EAST TOWN CROSSING FRONTAGE IMPROVEMENTS

COVER SHEET

EAST TOWN CROSSING SHAW ROAD IMPROVEMENTS

SHAW ROAD E TESC AND DEMOLITION PLAN

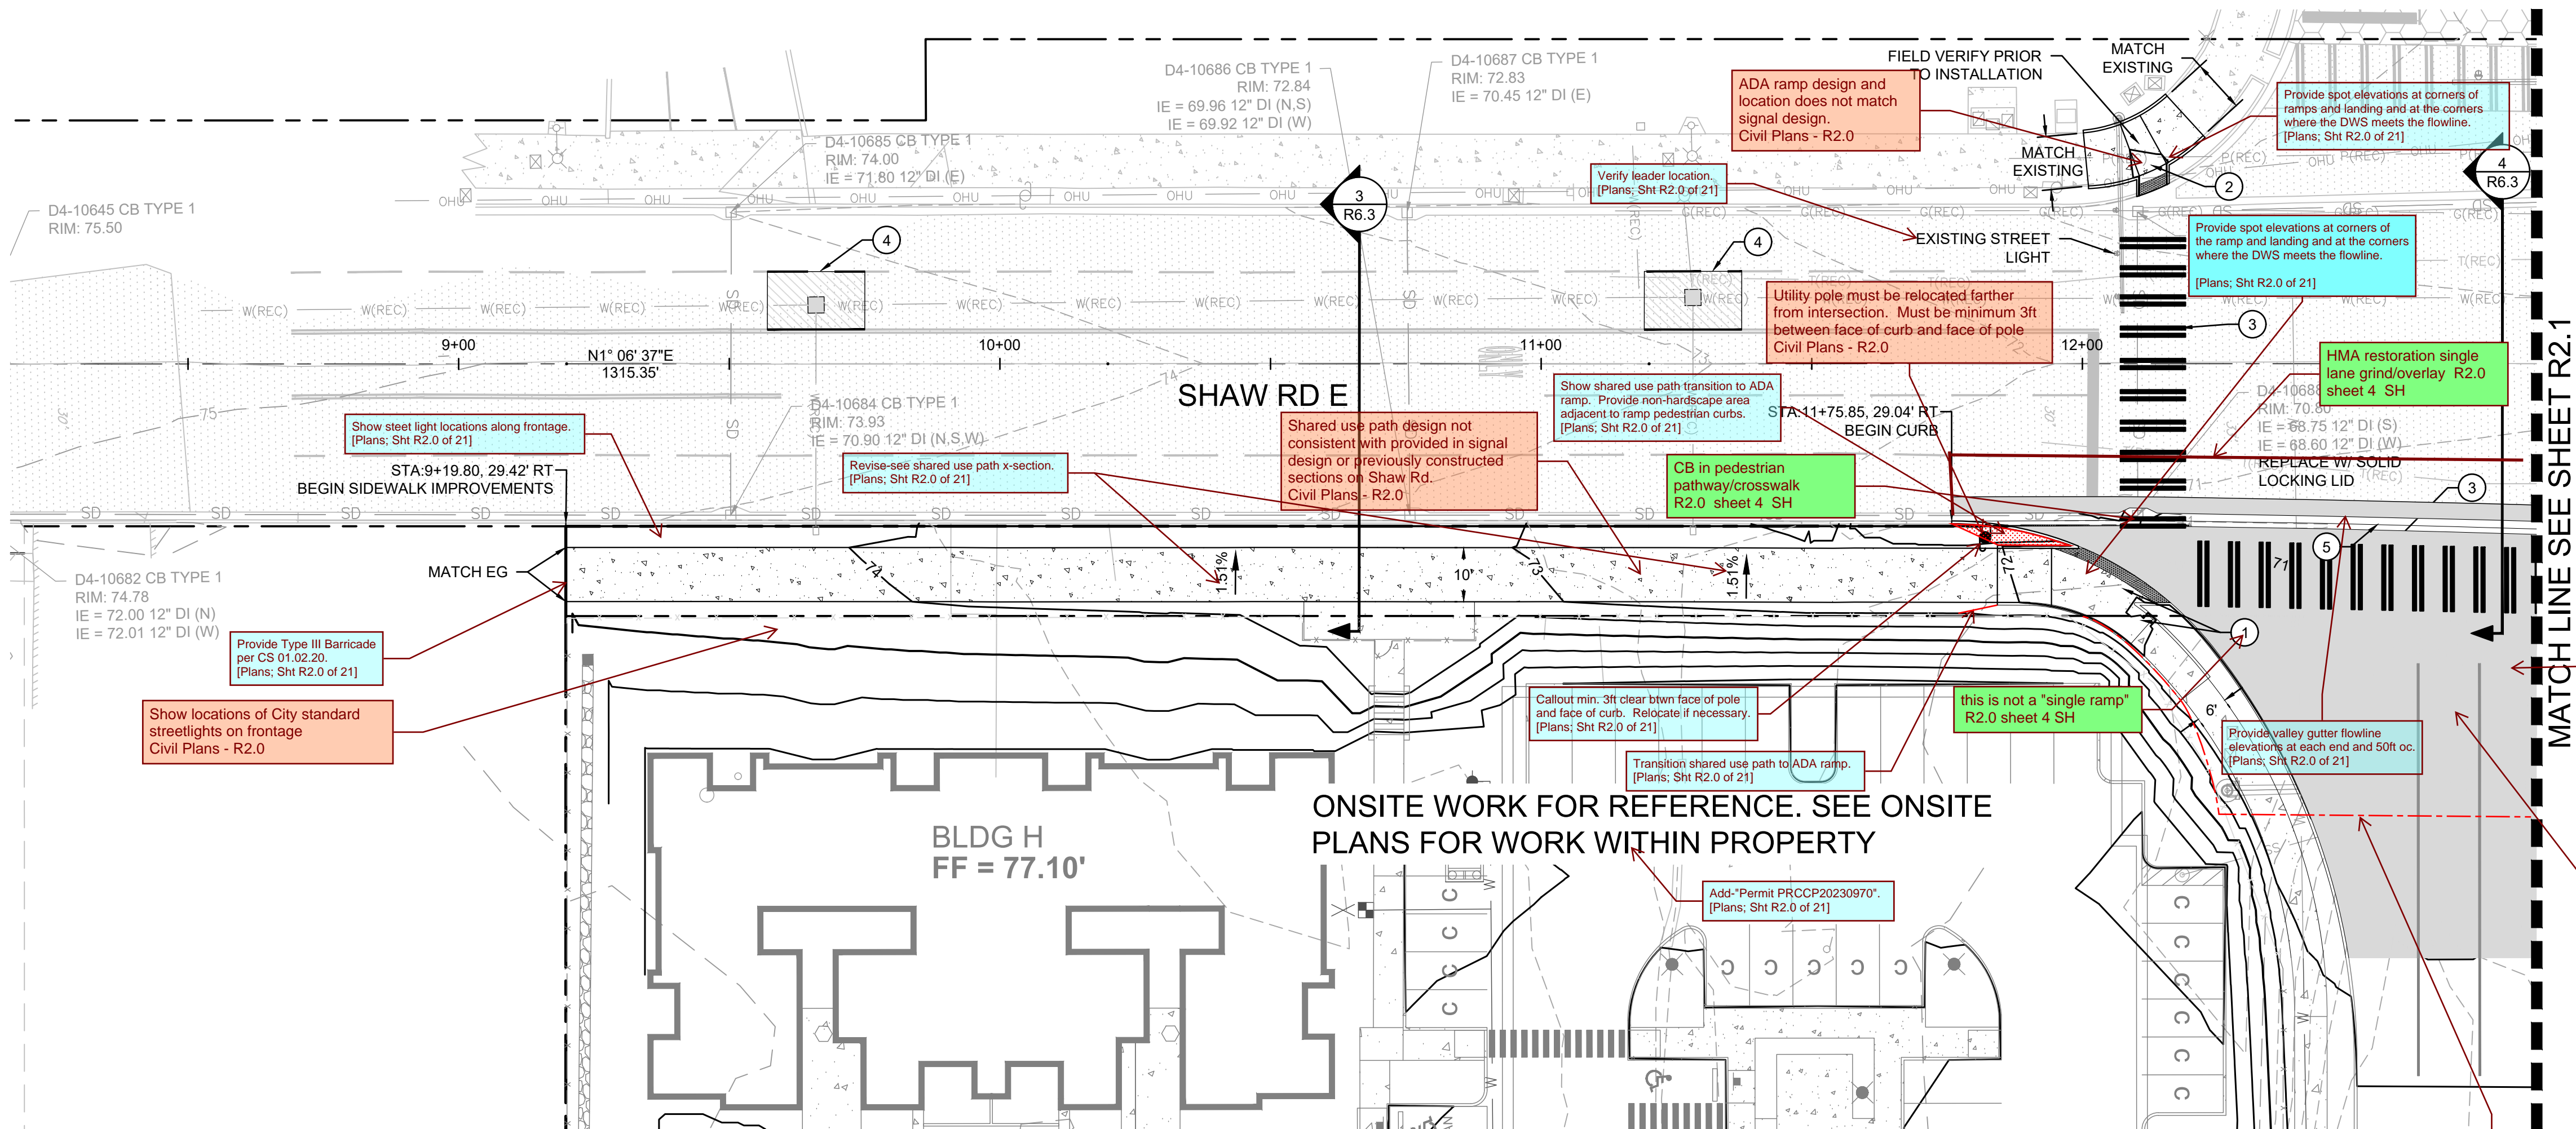
Add the following notes to the planset:

- Existing public utilities that are in conflict with proposed frontage improvements shall be relocated as necessary to meet all applicable City, State, and Federal requirements.
- Existing private utilities (power, gas, telecom, cable, etc.) that are in conflict with City maintained right-of way and utilities shall be relocated outside of the travelled road section, i.e., behind the curb under the sidewalk area or other location as approved by the City. [Plans; Sh: R1.1 of 21]

PIONEER WAY E TESC
AND DEMOLITION
PLAN

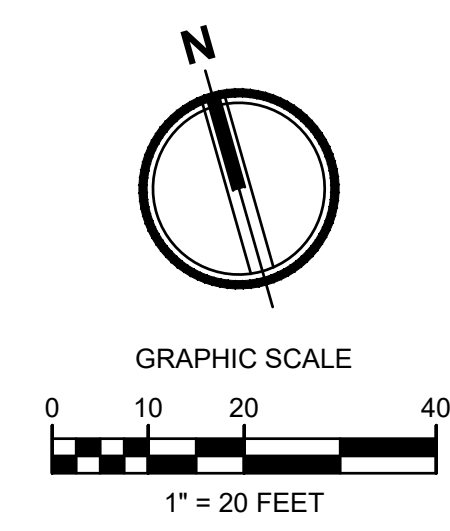
Add the following notes to the planset:
-Existing public utilities that are in conflict with proposed frontage improvements shall be relocated as necessary to meet all applicable City, State, and Federal requirements.
-Existing private utilities (power, gas, telcom, cable, etc.) that are in conflict with City maintained right-of-way and utilities shall be relocated outside of the travelled road section, i.e., behind the curb under the sidewalk area or other location as approved by the City.
[Plans: Sht R3.0 of 21]

Clarify-Keynote 4 is also being used for existing light standard and poles at the intersection.
[Plans: Sht R3.0 of 21]

Verify "Note 4" reference.
[Plans; Sht R3.1 of 21]

Future location must not interfere with future frontage improvements. PSE mounted streetlight to be removed. Lighting to be replaced by City standard lighting.
Civil Plans - R3.1

Sheet Title:
**PIONEER WAY E
CHANNELIZATION
PLAN**

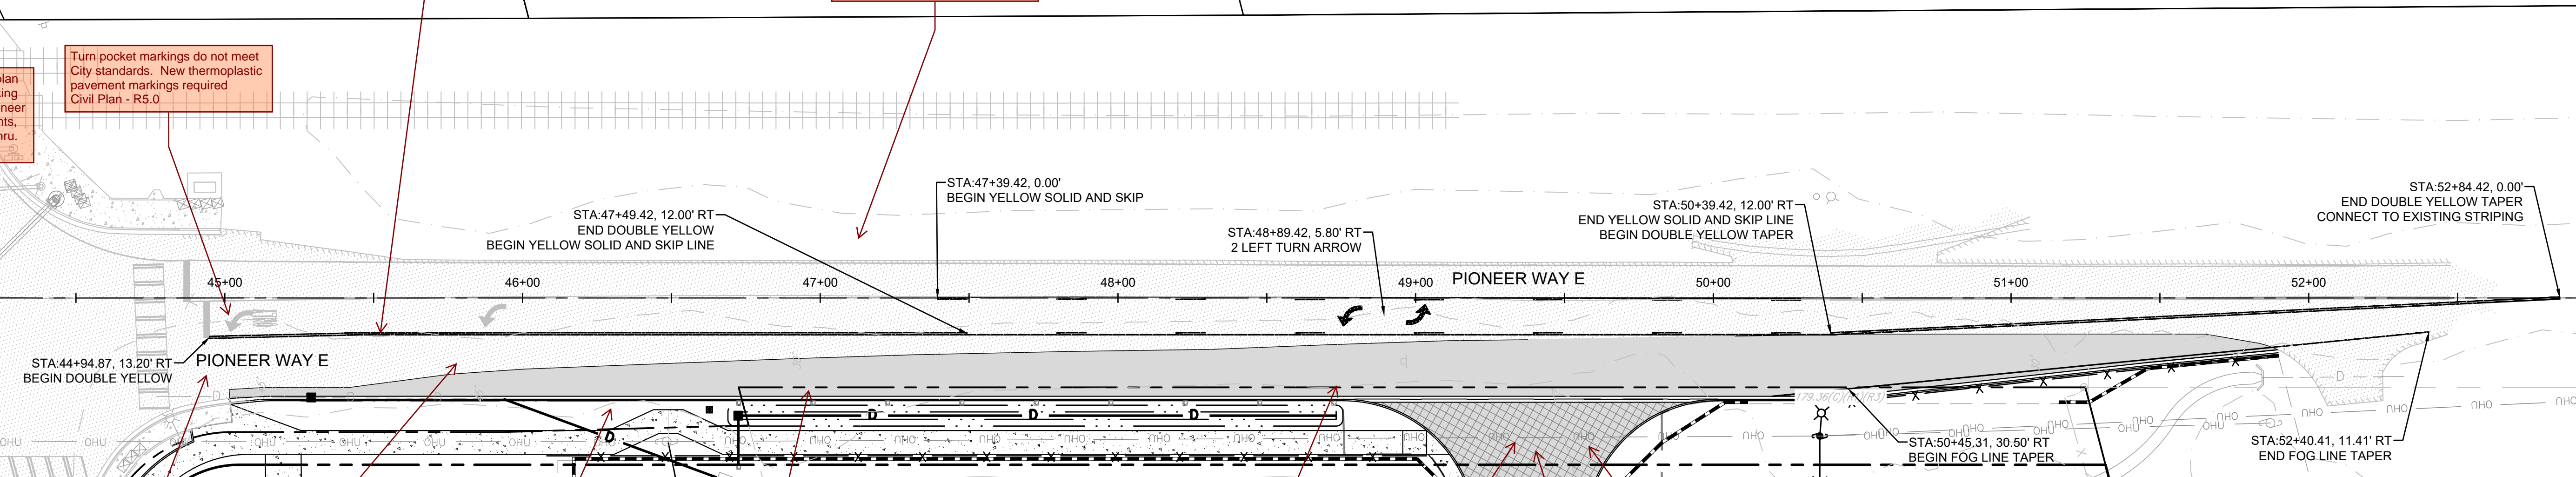
Prior to Occupancy, execute and record
"Private Road Maintenance Agreement" (for
maintenance of private striping within the
ROW) on form approved by the City Attorney.
[Plans; Sht R5.0 of 21]

Channelization?
Civil Plans - R5.0

Provide right turn pocket striping +
arrows -
Civil Plans - R5.0

Provide striping info for the approach.
[Plans; Sht R5.0 of 21]

Two EB lane striping not provided
Civil Plans - R5.0

Provide MUTCD compliant "RIGHT
LANE MUST TURN RIGHT"
signage
Civil Plans - R5.0

Provide short interval white skip
stripe in advance of solid white
gore for right turn pocket
Civil Plans - R5.0

Verify lane striping alignment with existing
striping on the west side of signal.
Civil Plans - R5.0

details for existing pavement
marking removal should be on this
sheet
Civil Plans - R5.0

Remove curvature
Civil Plans - R5.0

Turn pocket markings do not meet
City standards. New thermoplastic
pavement markings required
Civil Plan - R5.0

Per the approved preliminary site plan
conditions, striping/pavement marking
modifications required at Shaw/Pioneer
signal. With proposed improvements,
EB approach will allow two lanes thru.
Civil Plans - R5.0

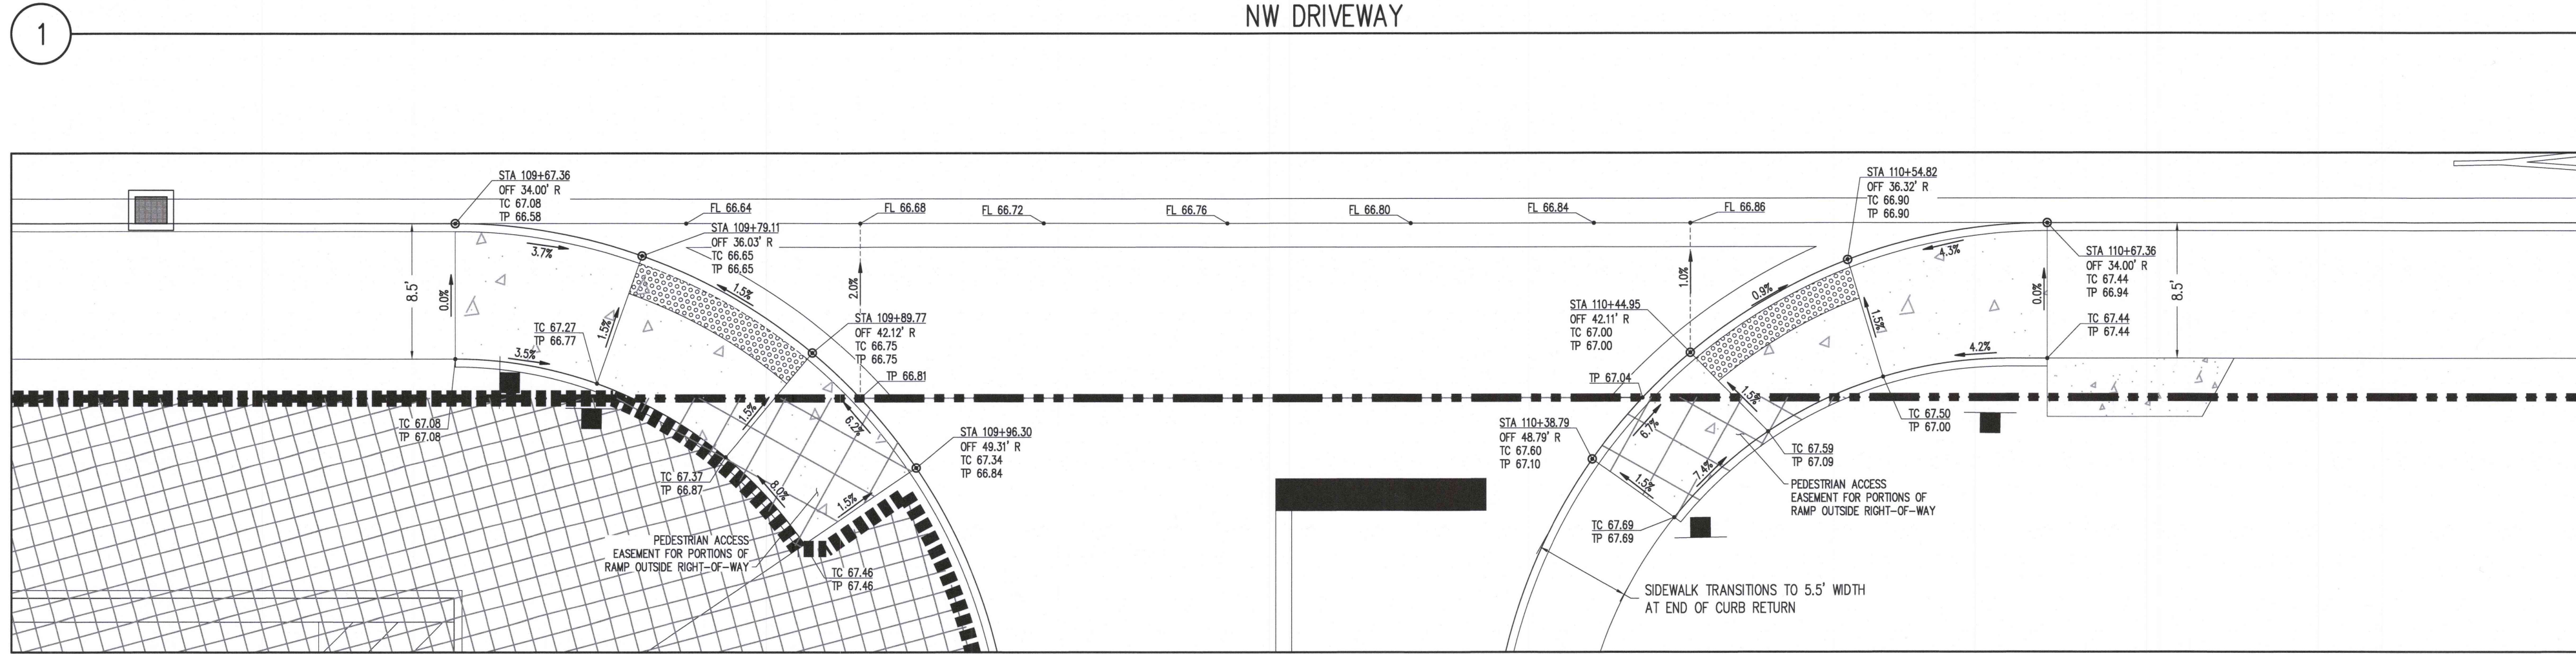
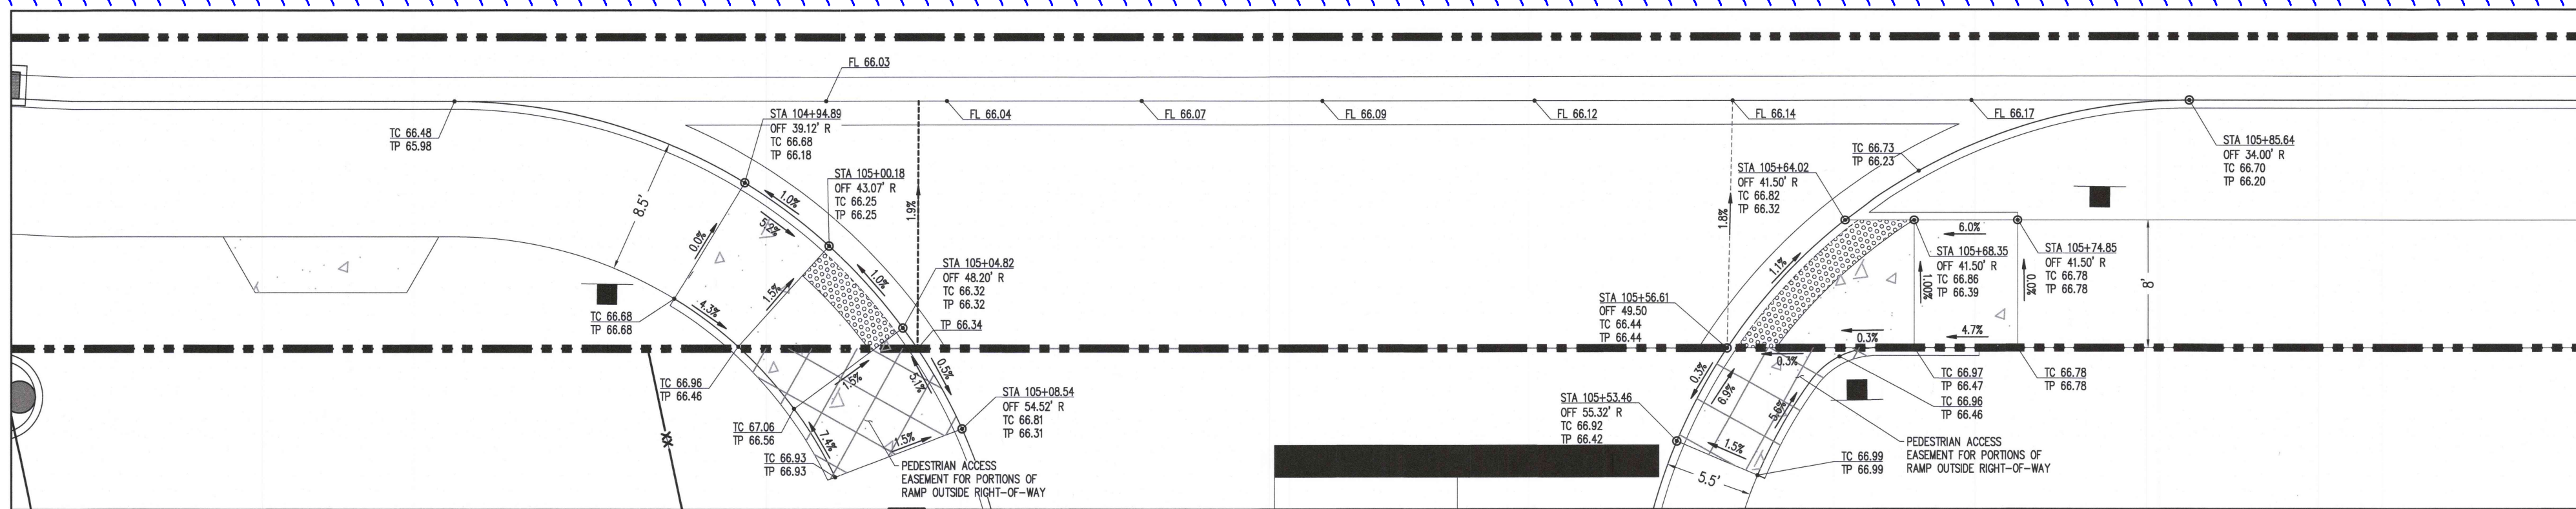
Examples of curb ramp designs with spot elevations...reference comments on frontage plans.
[Plans: Sht R6.1 of 21]

2 CONCRETE BOX CULVERT NOT TO SCALE

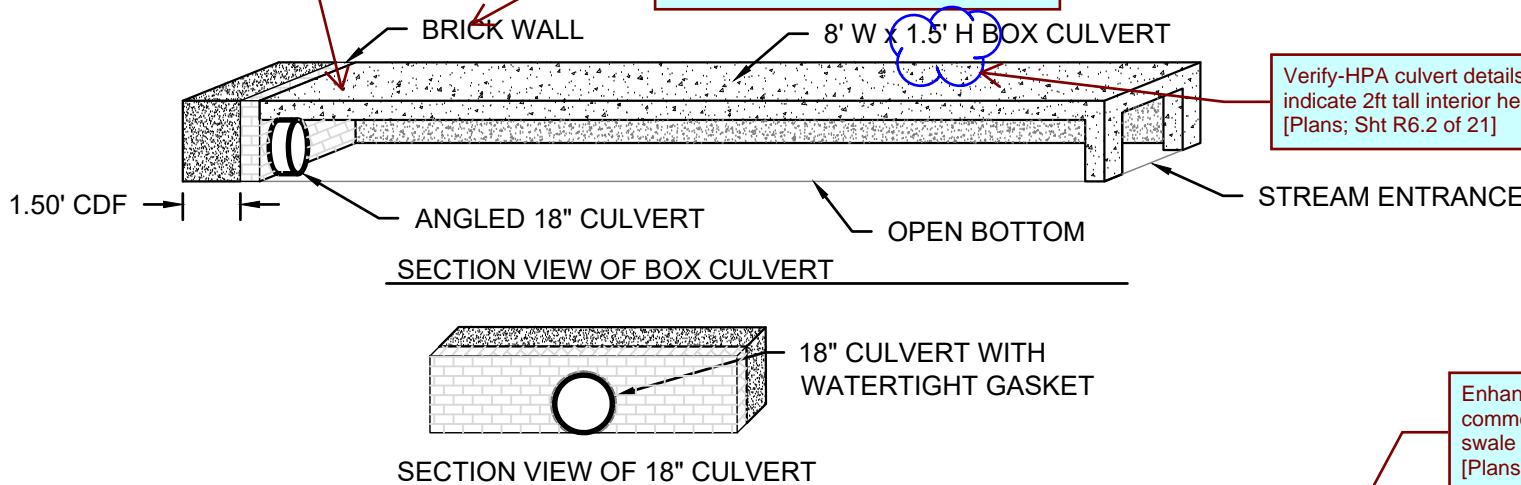
Provide maintenance access above pipe-culvert to-in. (See example above as on possible alternative). [Plans; Sht R6.2 of 21]

Provide CIP or precast end wall. If CIP call out reinforcing rebar. (See example above as on possible alternative). [Plans; Sht R6.2 of 21]

3 BIOFILTRATION SWALE NOT TO SCALE

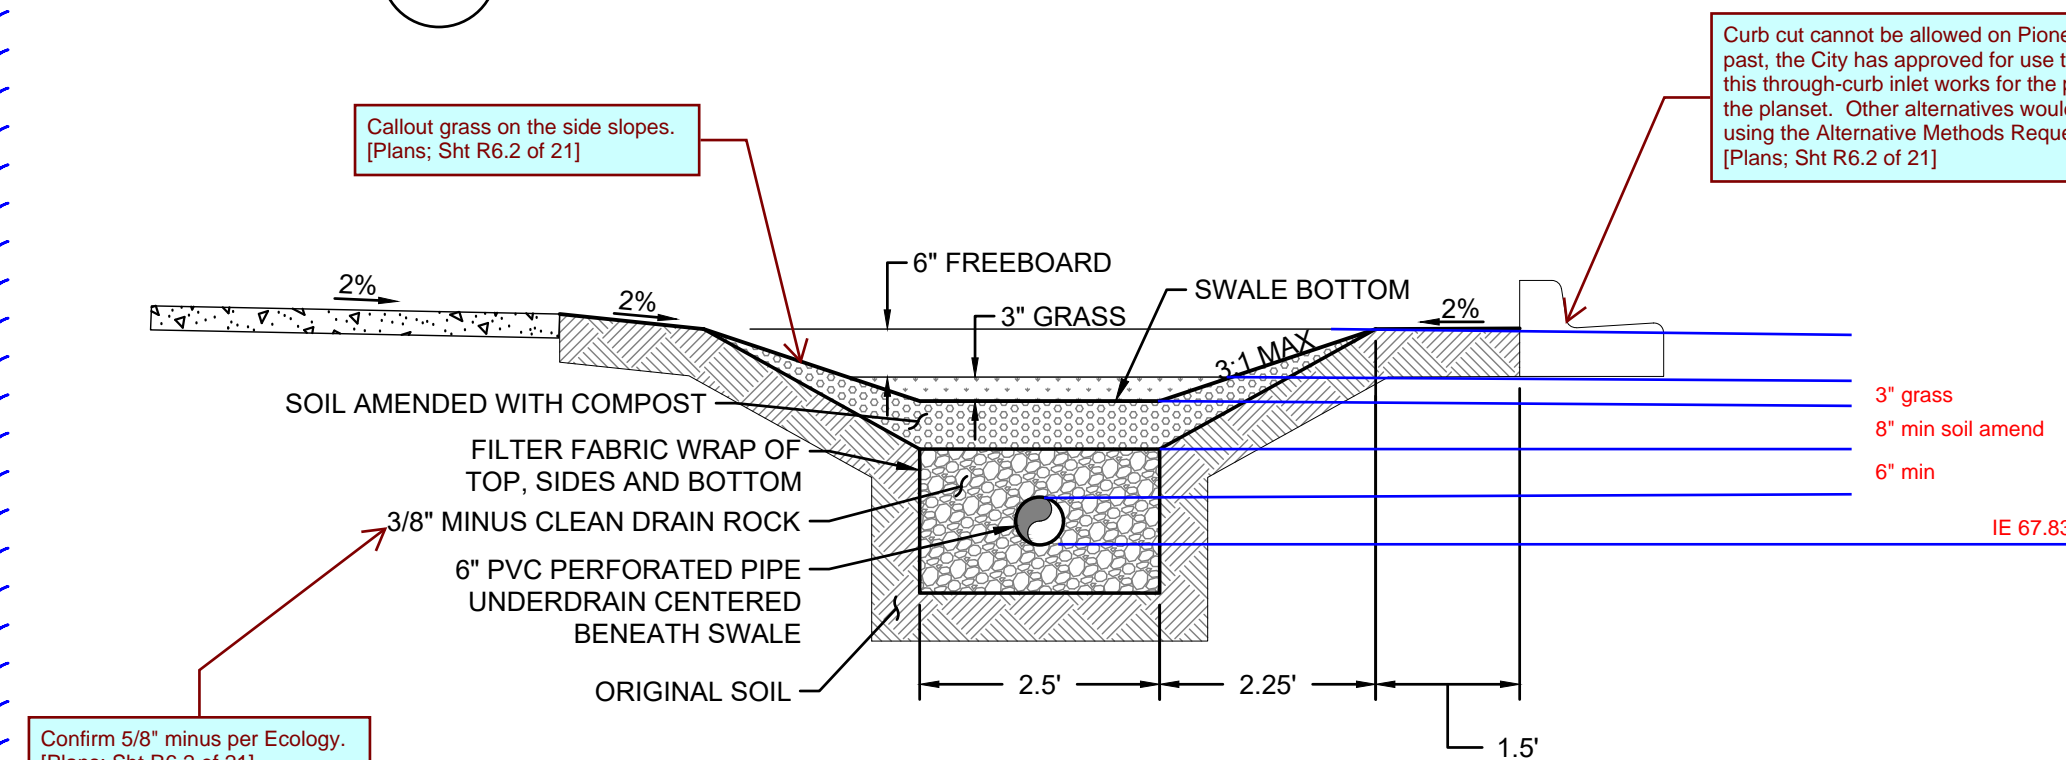
Callout grass on the side slopes. [Plans; Sht R6.2 of 21]

Enhanced Treatment required for Pioneer. The comments below are provided in case the biofiltration swale will still be utilized as part of a treatment train. [Plans; Sht R6.2 of 21]

Callout the following information for the WQ swale:
-grass seed mix criteria
-thickness of amended soil
-amended soil composition criteria
-filter fabric wrap rebar
-drain rock thickness above/below underdrain
-indicate groundwater elev. (E1, E2, E3) in relation to the x-section
-indicate synthetic impermeable liner and provide criteria. [Plans; Sht R6.2 of 21]
